# **FINAL DECISION**

## **United Energy Distribution Determination 2021 to 2026**

### **Attachment 5 Capital expenditure**

April 2021

**Figure A.1 Historical vs forecast repx (\$ million, 2020–21)**

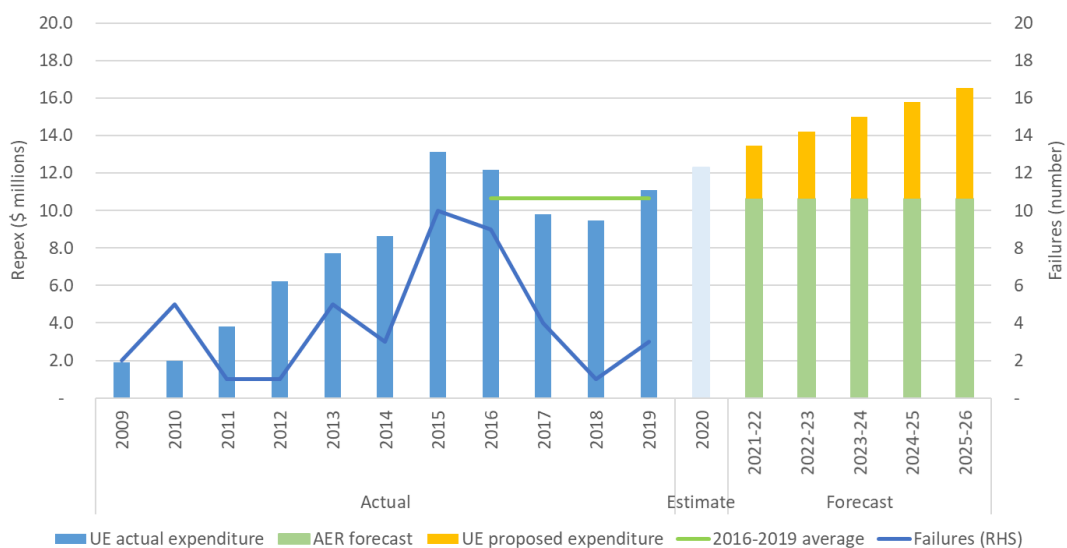
Figure A.1 shows United Energy’s wood pole repx since 2009, its forecast repx for 2021–26, as well as our forecast. United Energy is forecasting an upward trend in expenditure for 2021–26 relative to the current regulatory control period.

**Figure A.2 Repex model results – wood poles (\$ million, 2020–21)**

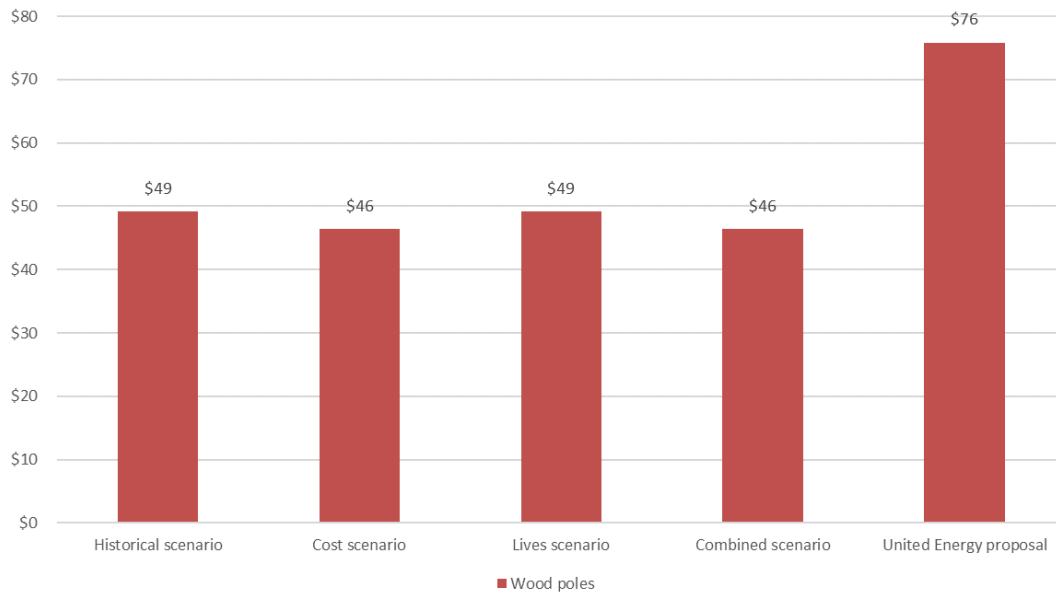
Figure A.2 shows United Energy's revised proposal for wooden poles is \$27 million (54 per cent) higher than our repex model threshold (the lives scenario).<sup>32</sup> This suggests that United Energy's wood poles forecast may not be prudent and efficient and compares unfavourably when benchmarked against other distributors in the NEM. Further, the repex model threshold of \$49 million is the same as the historical scenario, suggesting that a forecast similar to United Energy's historical expenditure may more reasonably reflect efficient costs.
